DRAINAGE STRATEGY ADDENDUM

1 Ferdinand Place, London, NW1 8EE

P2875		Drainage Strategy Addendum, Ferdinand Place, London, NW1 8EE				
Revision Date of issue		Comments	Prepared By	Checked By		
1.0	22/08/2016	First Issue	EB	AJ		
2.0	23/08/2016	Minor Updates	AJ	DB

Scheme Address	1-3,4,6,8 Ferdinand Place
Planning Reference	2016/2457/P
Size of site (as stated on application form)	0.0615Ha + 0.0310Ha
Date	14/06/2016
Recommendation:	Refuse until further information is provided

Location of development relative to Local Flood Risk Zone:

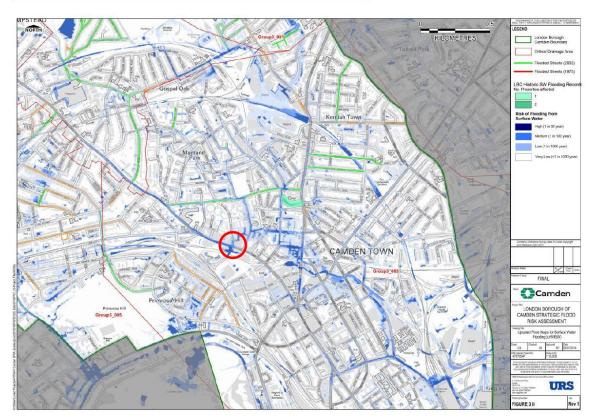
- 3.1 Camden Council in their response stated that a Flood Risk Assessment was not submitted as part of the Application and that a Flood Risk Assessment (FRA) was required.
- 3.2 This was reviewed against NPPF and Local Policy. The existing site is less than 1 hectare in size and is in Flood Zone 1. Therefore, a Flood Risk Assessment is not required by NPPF. All forms of flooding were assessed as part of the drainage strategy.
- 3.3 The Camden response also highlighted the lack of reference to critical drainage areas in the report. The map above indicates the site does lie within a critical drainage area (marked red).

- 3.4 The Camden SFRA indicates that a site within a critical drainage area is not necessarily at greater risk than one outside, but any undeveloped land should be considered as detrimental to the area.
- 3.5 The site is not only previously developed and 100% hardstanding, it has been shown to not be at risk from any forms of flooding. Therefore the fact it is within a critical drainage area should not impact the site development potential.

Location of development relative to Local Flood Risk Zone:

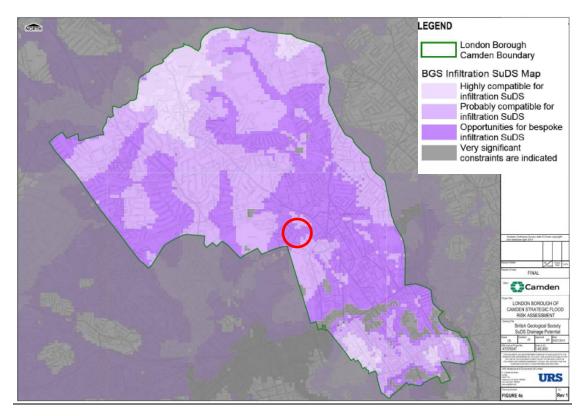
Comment: Development is in Flood Zone 1 therefore low risk of river flooding. The applicant's Drainage Strategy states that risk of groundwater flooding should be relatively low but that sustainable construction techniques for surfacing should minimise any potential groundwater risk. No evidence of historic sewer flooding on the site.

The SFRA maps indicate the site is at risk of surface water flooding (1/100 year event) with sites nearby at risk of flooding in the 1/30 year storm event. Therefore the development should seek to reduce surface water run off to greenfield or 50% existing to minimise risk on site and downstream.

3.7 The surface water flood risk is localised to the adjacent roads and does not appear to encroach the site boundary. This is reflected in the Camden mapping. Therefore, the risk to the development area is considered minimal.
